Nine Mile Creek Discovery Point

MEMO

**RE: LHB Architects office space schemes**

# NINE MILE CREEK WATERSHED DISTRICT OFFICE ADDITION

PLAN SCHEME A | 08.27.2018

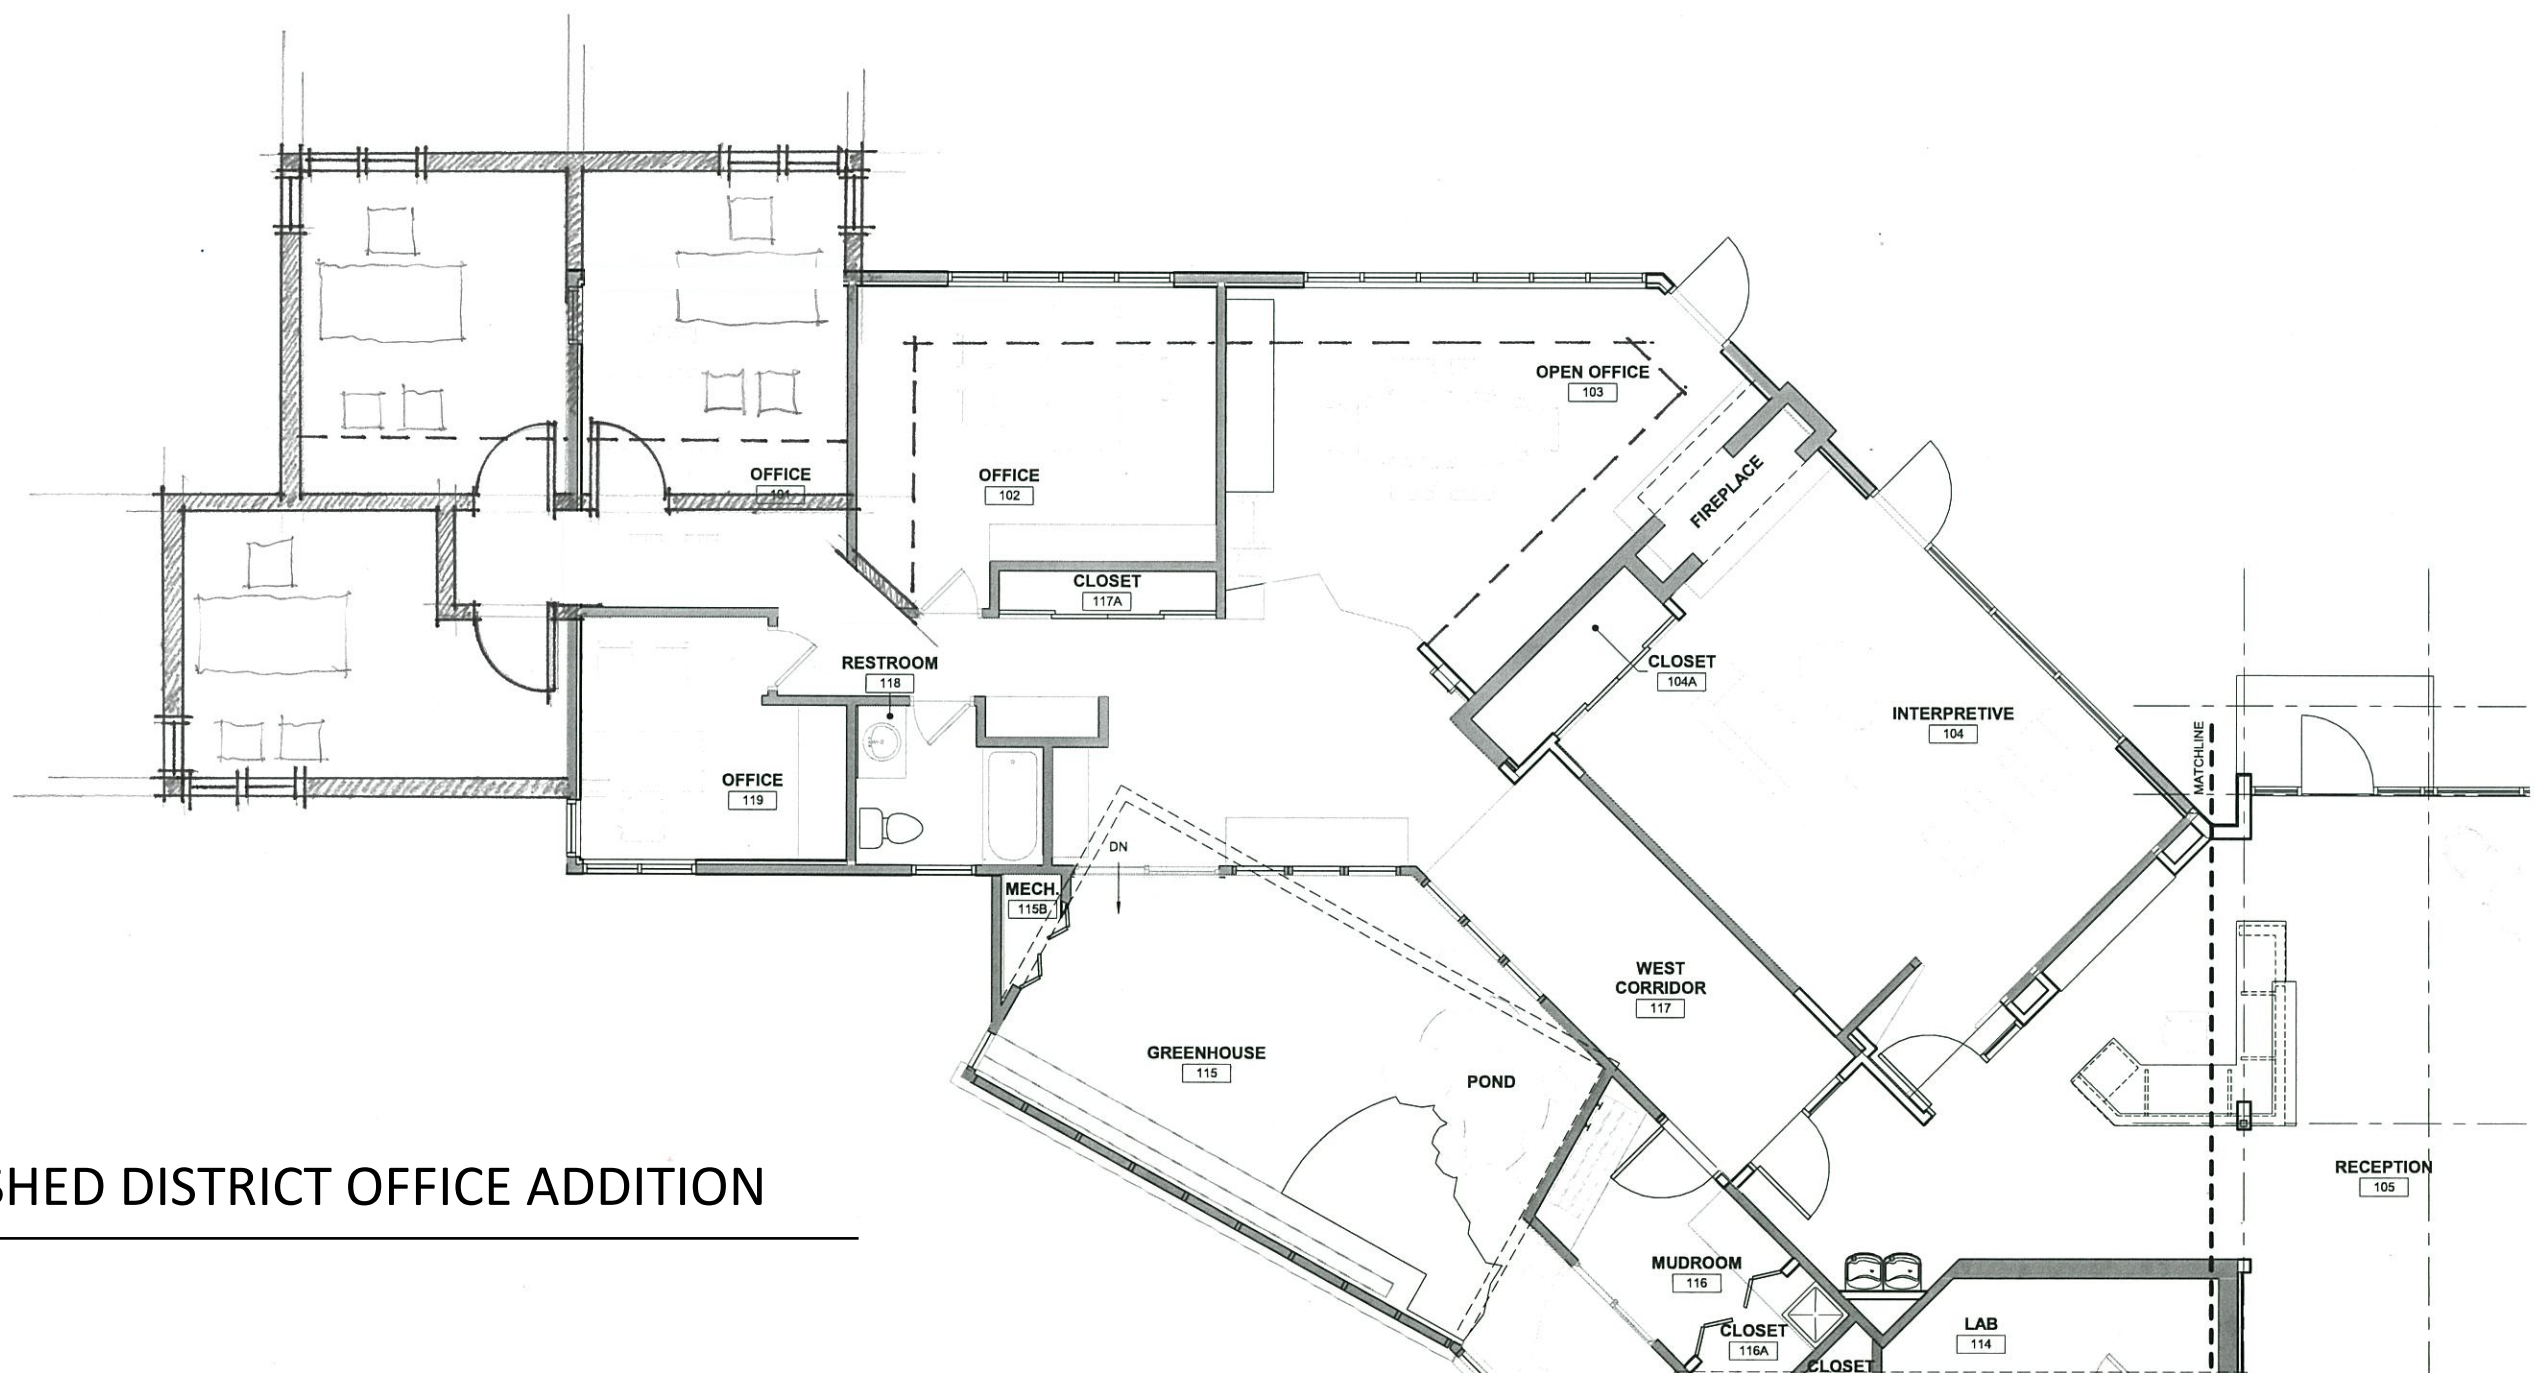
Plan Scheme A – This is their preferred scheme.

- Maintains views to exterior from open office area 103.
- All existing offices should be able to be used during construction.
- The window in office 102 (my current office) has been reduced.
- The soffits are re-worked a bit (dashed lines) so we would not have to walk under a really low ceiling to get to the new offices. I think the existing ducts could be modified to run in the new roof structure so the ceiling can be kept high over the circulation.
- Creates privacy for new offices. They do not open directly onto the open office area.
- Existing roof drainage would need to be changed. The addition is located where a roof scupper is currently located.
- Of the three schemes, I would assume that this would be more costly than scheme C but less than scheme B.

PLAN SCHEME B | 08.27.2018

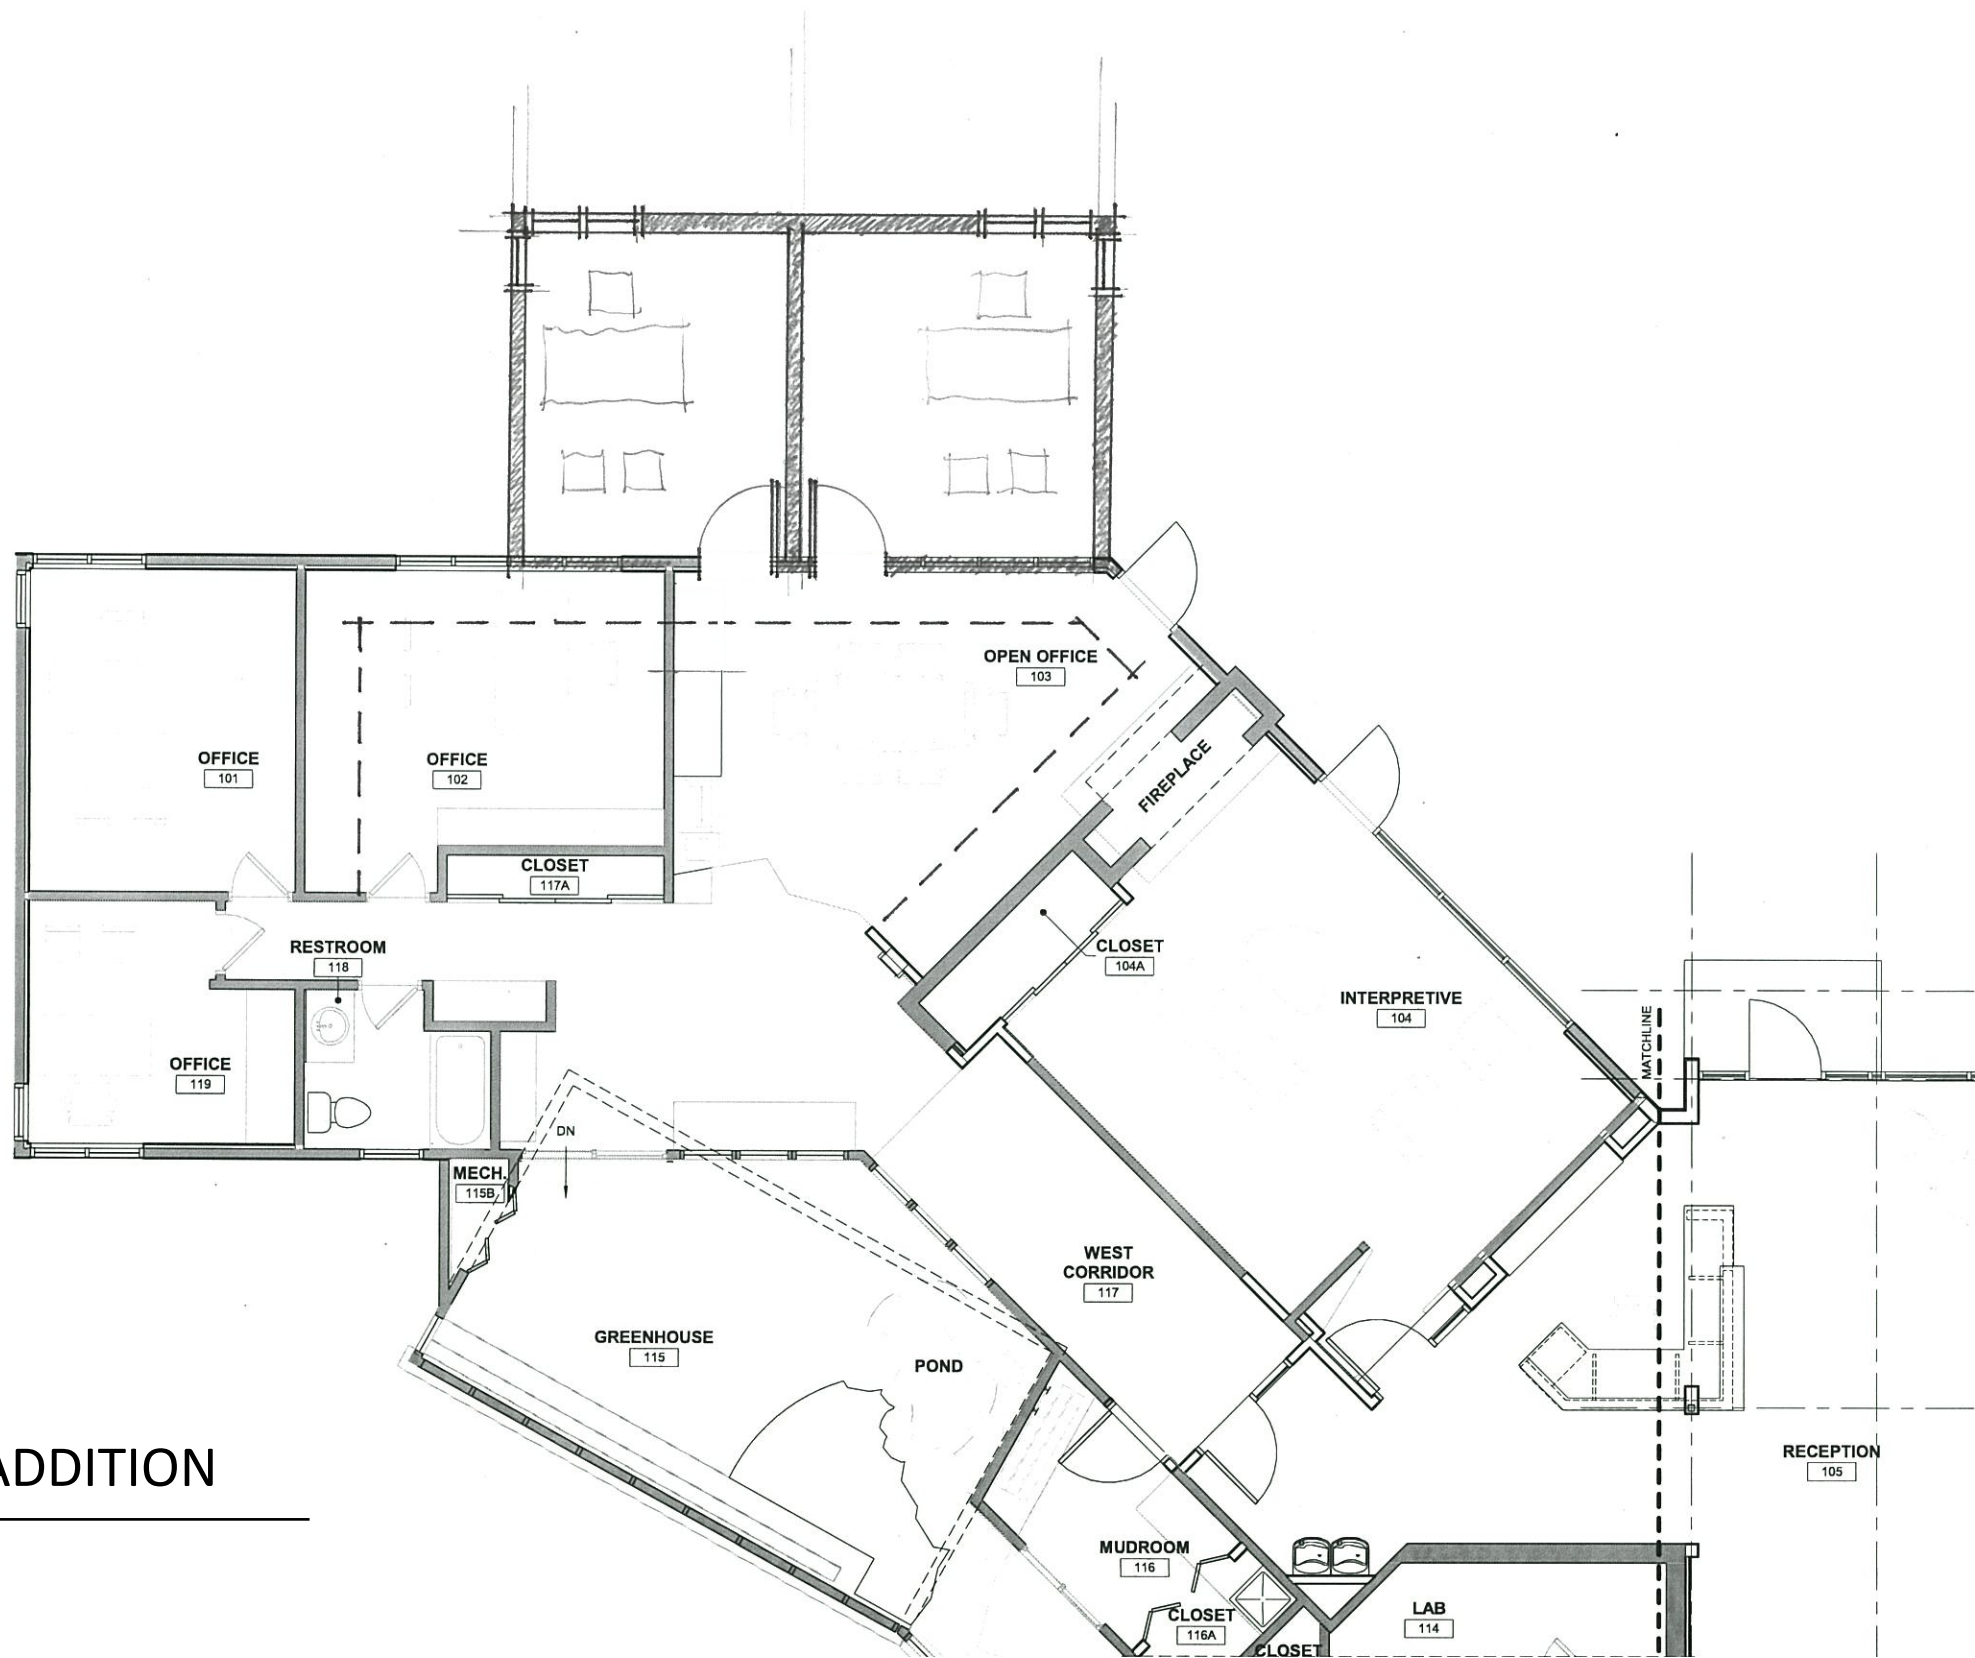
Plan Scheme B

- Maintains existing views out of rooms 102 and 103.
- Office 101 will not be able to be used during construction.
- Creates most privacy for new offices of the three schemes.
- Worked to keep addition as far north as possible and away from the existing tree. This would need to be studied in more detail to confirm that the tree would not be negatively impacted.
- Should not impact existing roof drainage significantly.
- Of the three schemes, I would assume that this would be the most expensive based on the amount of both addition and renovation work.
